# SERVICE LETTER

Letter No: **SL1011**

Product: All Toyotas

Issue: Starter Cable Routing

## P-CLAMP LOCATIONS (OEM Wiring)

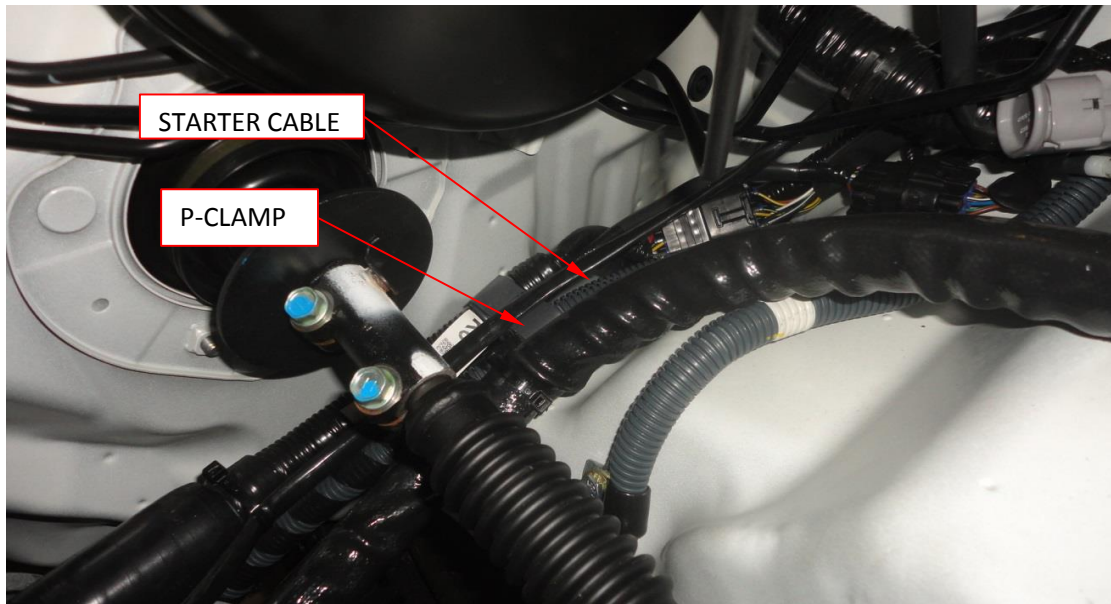
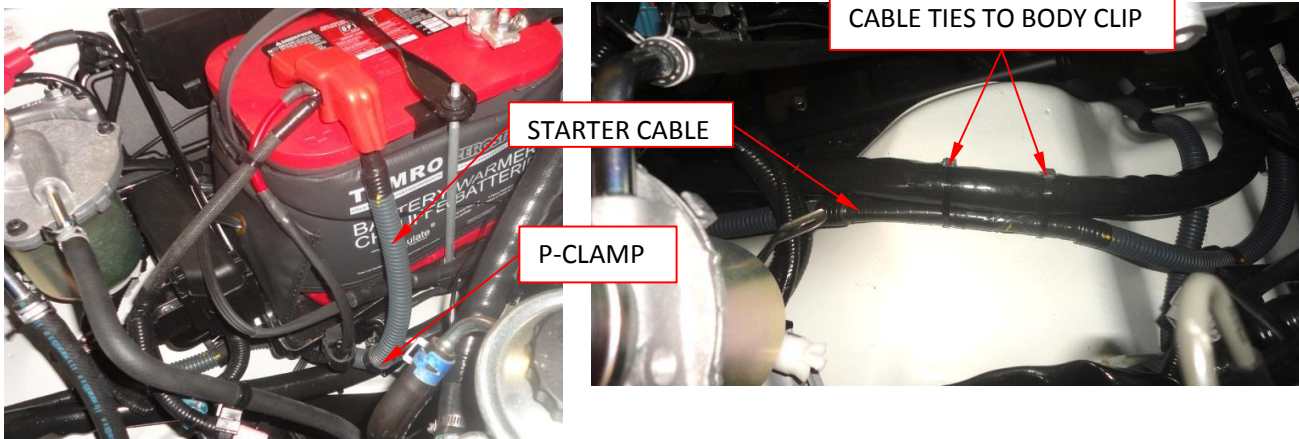
The following issue affects all Toyotas. On 1 occasion a Toyota had a fire caused by the starter cable shorting out. If the OEM P-Clamps open or let go, it may cause the starter cable to rub and wear out resulting in a dead short and possibly causing a fire.

Warning - If the starter cable routing is not verified and corrected if necessary, the cable may wear resulting in a dead short and possibly causing a fire.

Customer to verify that starter cable is correctly routed and supported. Ensure all p-clamps are properly secured. Check for any wear points on cable.

## Starter Fuse Field Kit

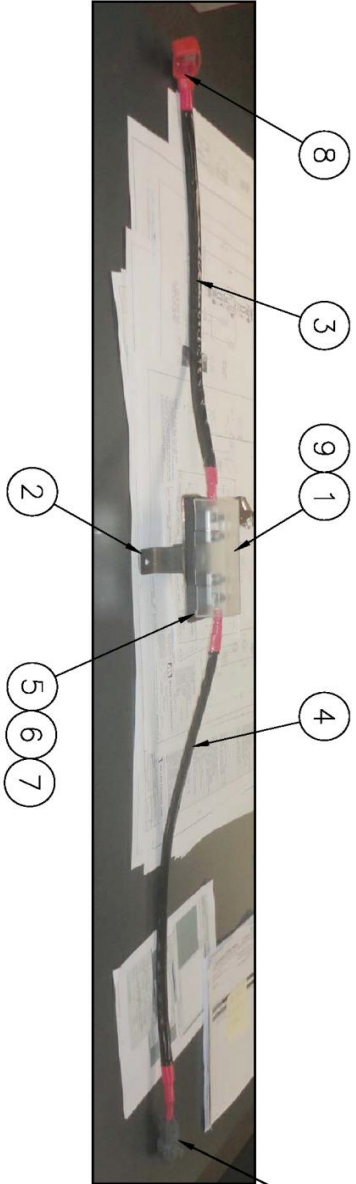
If customer wishes to have extra protection on the starter cable, Field Service Kit - 600A Fuse Kit w/ starter cable available for purchase. Please contact our Parts Department to order kit # 846745.

CUSTOMER TO REMOVE STARTER  
TERMINAL COVER FROM  
STARTER ON TRUCK
